Quality Control Check Report. Stage: After Finishing Stage. II (Apartments)

Flat No	A-903	Other	Sl. No.	38459
Company	MPL	Project	Phase	-
Prepared by	T. Vinod Kumar	Sign	Date	25-09-21
Project Manager	Subba Reddy	Sign	Date	25-09-21
Previous stage report no.	27799	Report filed and signed by PM	☒ Yes ☐ No	
Checked By MD on	MD Sign	For filling	☐ Yes ☐ No

Details of Additions & Alterations

Flat No	903	Block no.	'A'
Flat Area	1500 sft	Type	Deluxe / Luxury
Buyer Name	K Chaitanya Reddy		
Phone No.	8919245094/9348311999	Email	KCREDDY03@GMAIL.COM

ELECTRICAL PLAN OF FLAT-A3

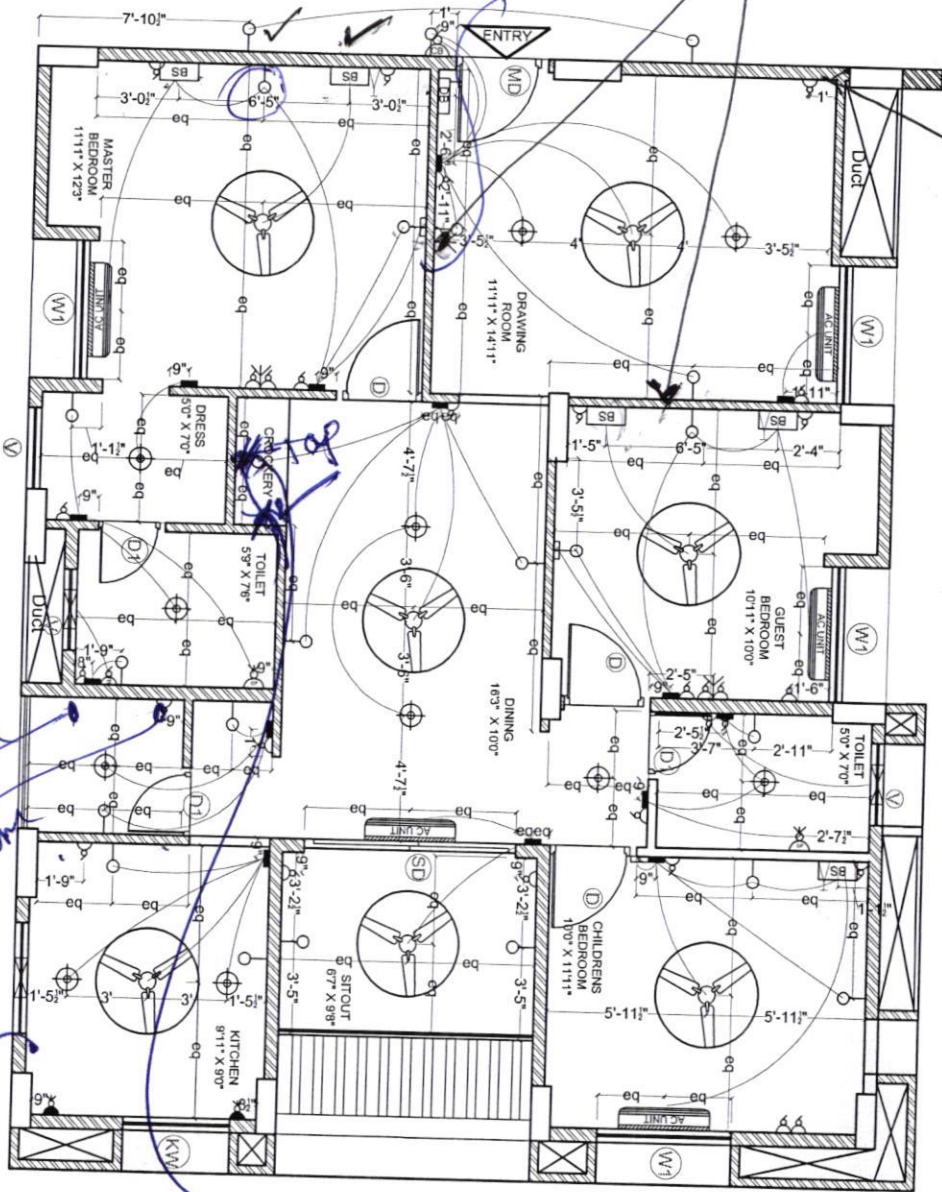
Changes in electrical points: (mark on plan)

① marked on plan

WORKING DRAWING OF FLAT NO. A-3

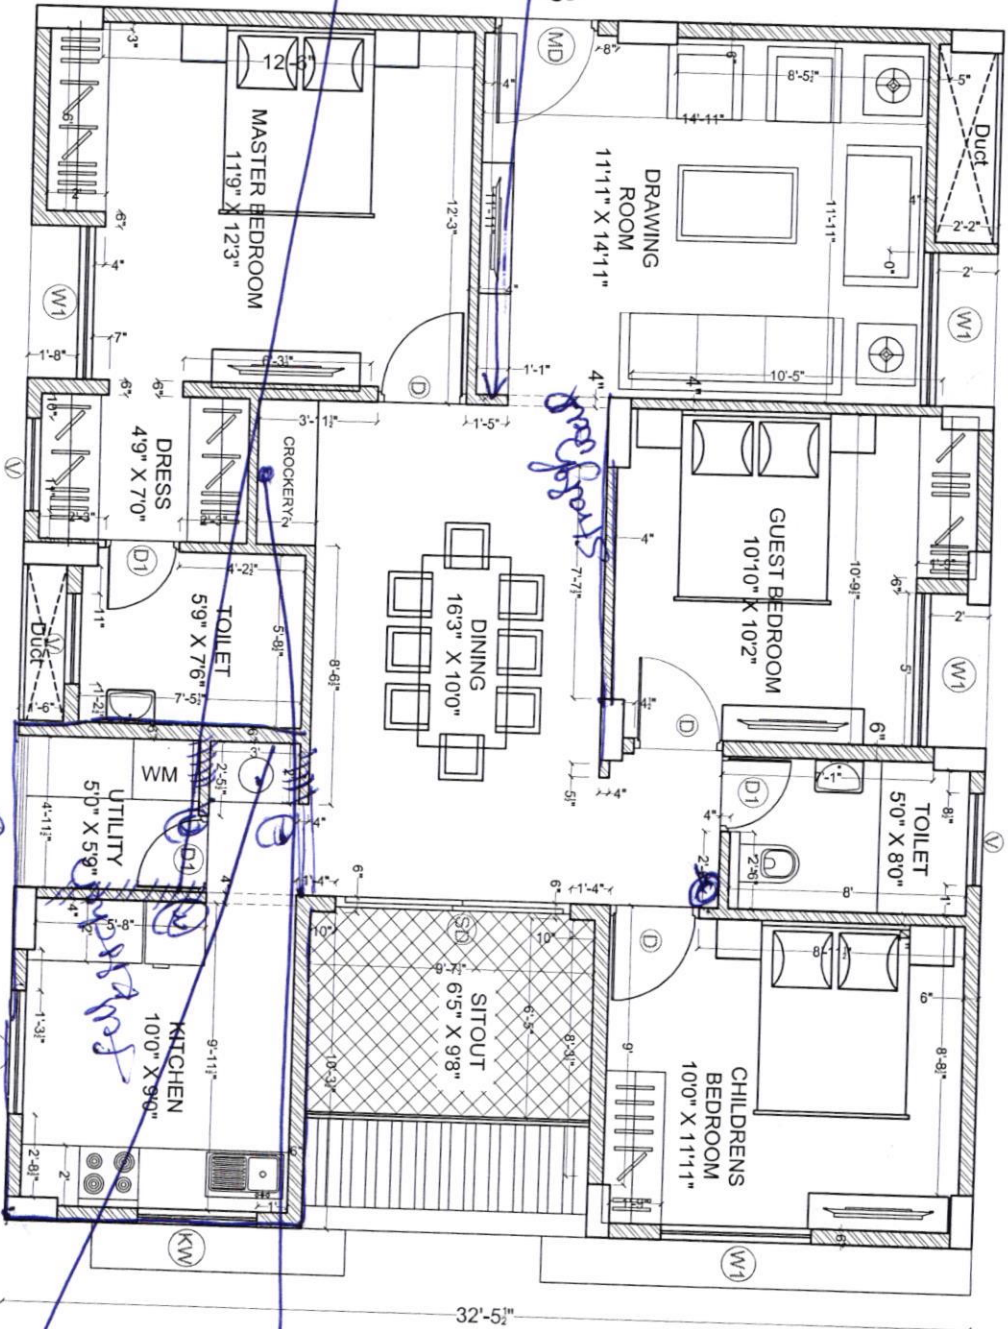
15mm or 18mm
to be removed
